Technical Bulletin

DP02	TB0023-2008	Elan Motorsports Technologies	
From:	Chip Lewis		
Subject:	<i>Brake Pad Thermal Shim</i>	Date:	March 3 rd , 2008

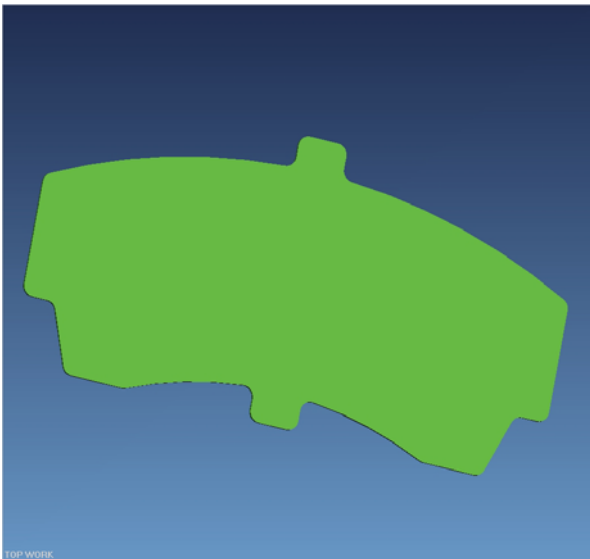
Available to order is an optional Brake Pad Thermal Barrier Shim (Stainless Steel), DP02-10-006. The shim acts as a thermal barrier to help lower brake fluid temperatures. A DP02 requires 8 total shims (2 per brake calliper). Each shim has two tabs on it that a team can use to help retain the shim, or cut off. Teams may modify the shim slightly for fit, but the overall shape must remain as delivered.
